RE: Responses to WDEQ/LQD Technical Comments
Lost Creek Project - Great Basin, Wyoming
NRC Docket No. 40-9068

**RESPONSES TO WDEQ/LQD COMMENTS
of 1/30/2009
and
NEW INFORMATION**

**for the
LOST CREEK PROJECT
Wyoming**

October 2009

Figure 4-1 Uranium and Conductivity Trends During the RO Permeate Injection Phase of Restoration, Module 51, Mine Unit 5, Christensen Ranch, Wyoming

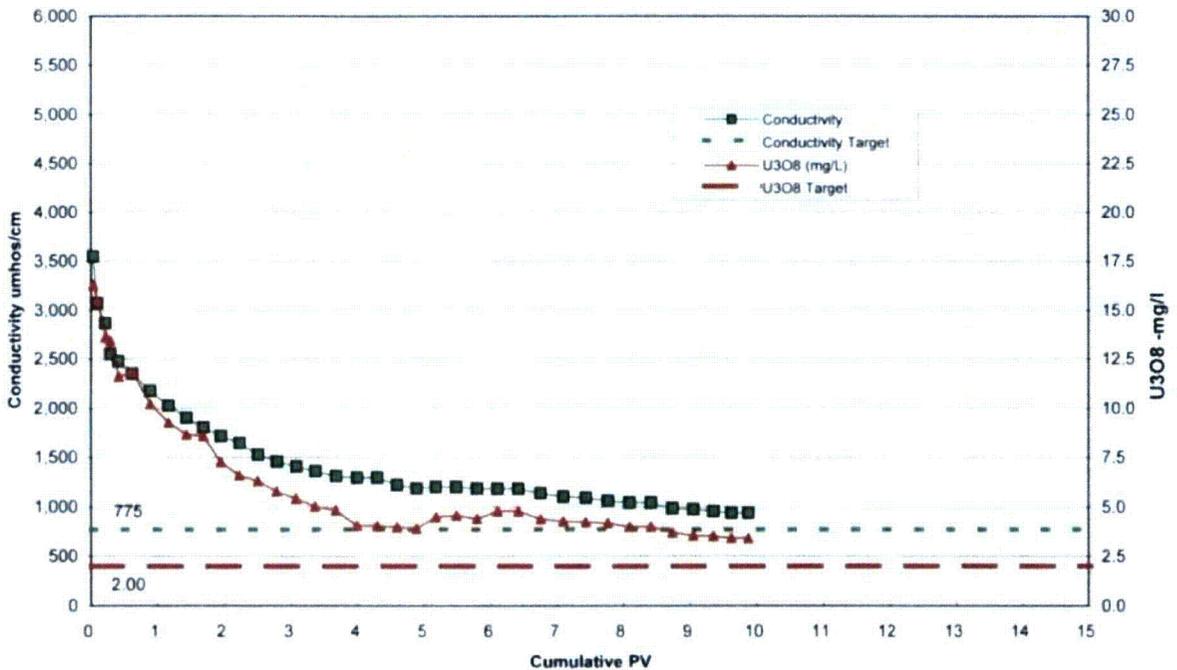
In Module 51, RO (including recirculation) was conducted for nearly 10 pore volumes (PV). The uranium and TDS concentration graphs indicate a meaningful plateau was reached near four PV and little improvement in water quality occurred beyond that point (see Figure 4-1 below).

Figure 4-2 Uranium and Conductivity Trends During the RO Permeate Injection Phase of Restoration, Module 52 , Mine Unit 5, Christensen Ranch, Wyoming

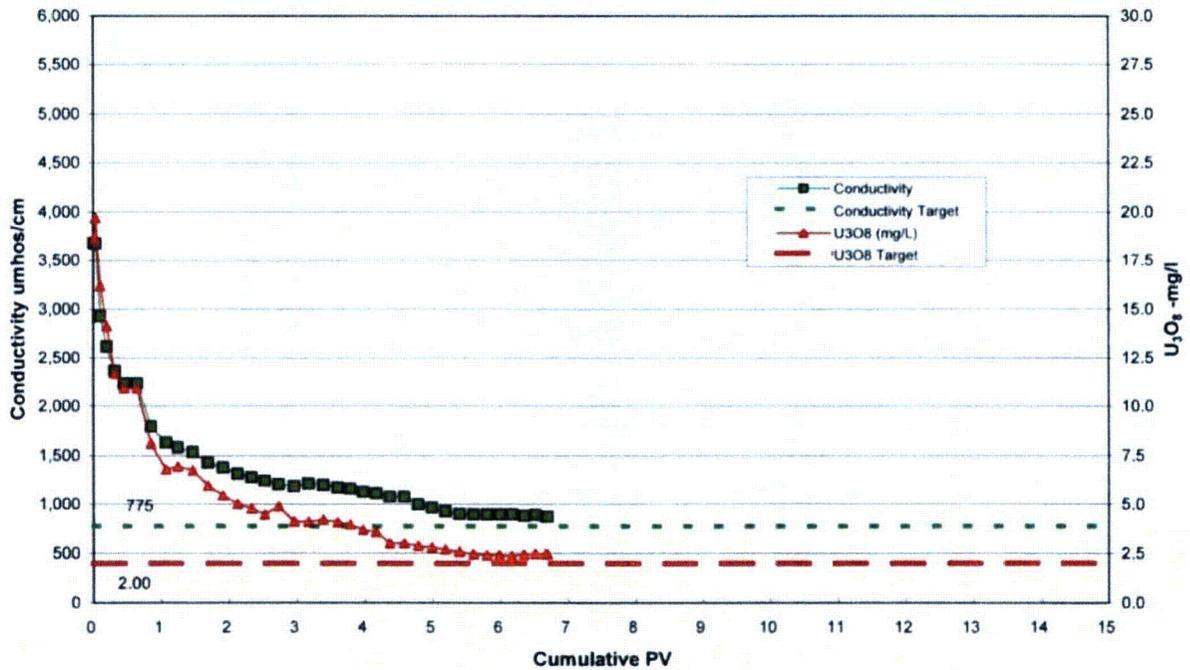
In Module 52, RO (including recirculation) was conducted for nearly seven PV. The uranium and TDS concentration graphs indicate a meaningful plateau was reached near four and one-half PV and little improvement in water quality occurred beyond that point (see Figure 4-2 below).

Figure 4-3 Uranium and Conductivity Trends During the RO Permeate Injection Phase of Restoration, Module 53, Mine Unit 5, Christensen Ranch, Wyoming

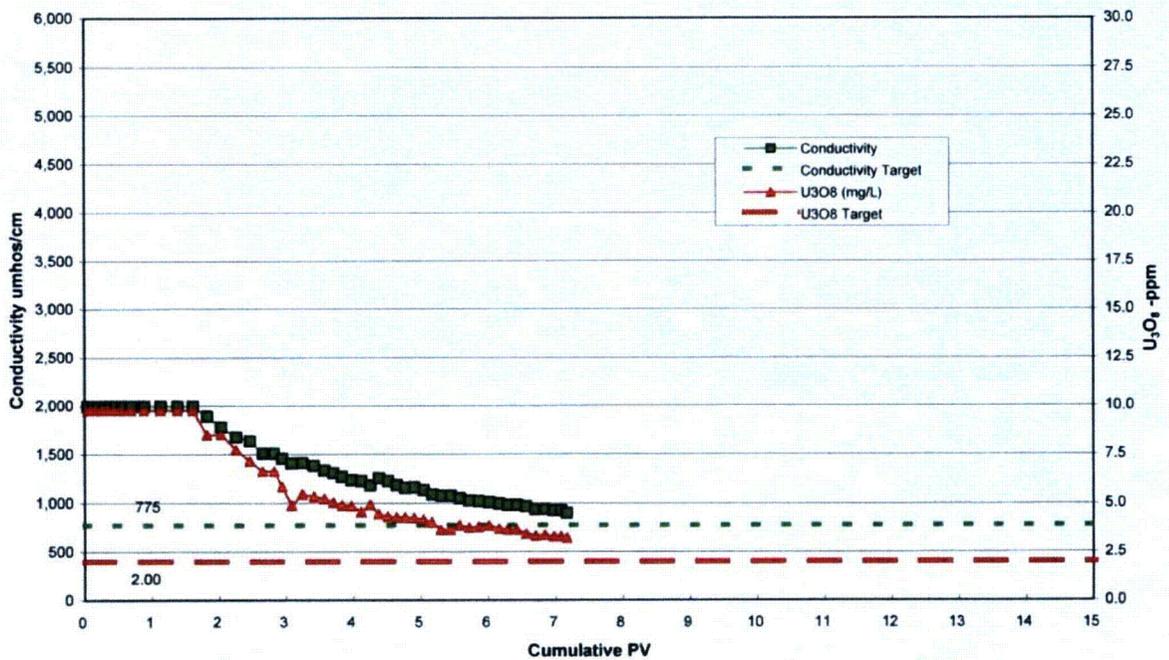
In Module 53, RO (including recirculation) was conducted for more than seven PV. The uranium and TDS concentration graphs indicate a meaningful plateau was reached near five PV and little improvement in water quality occurred beyond that point (see Figure 4-3 below).

Figure 4-4 Uranium and Conductivity Trends During the RO Permeate Injection Phase of Restoration, Module 54 , Mine Unit 5, Christensen Ranch, Wyoming

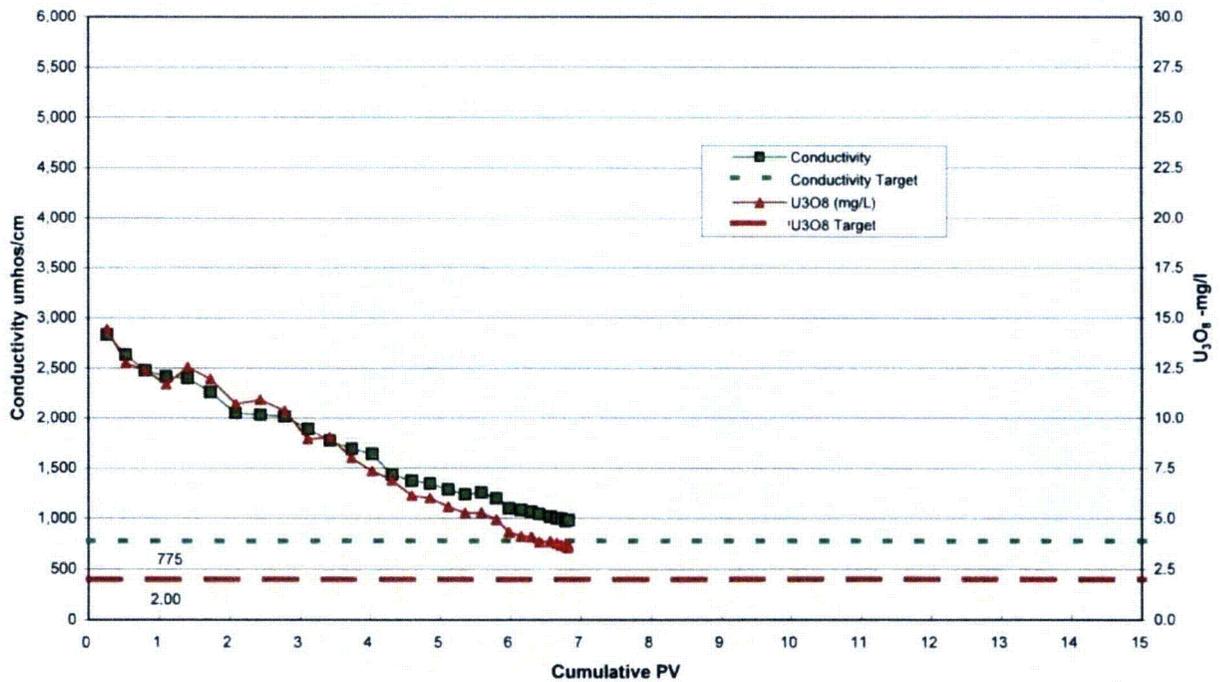
In Module 54, RO (including recirculation) was conducted for nearly seven PV. The uranium and TDS concentration graphs indicate a meaningful plateau was reached before 5 PV and little improvement in water quality occurred between five and six PV (see Figure 4-4 below). Pore volumes 6 through 7 were recirculation only.

Figure 4-5 Uranium and Conductivity Trends During the RO Permeate Injection Phase of Restoration, Module 55, Mine Unit 5, Christensen Ranch, Wyoming

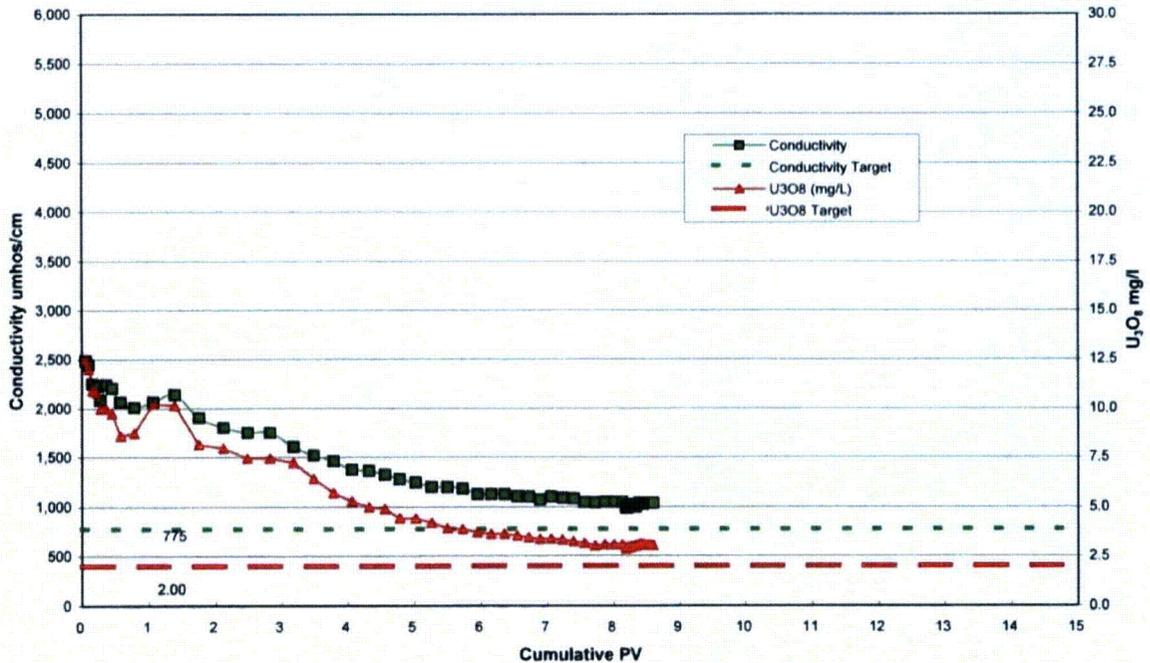
In Module 55, RO phase was conducted for nearly nine PV. The uranium and TDS concentration graphs reached a meaningful plateau before six PV and little improvement in water quality occurred beyond that point (see Figure 4-5 below).
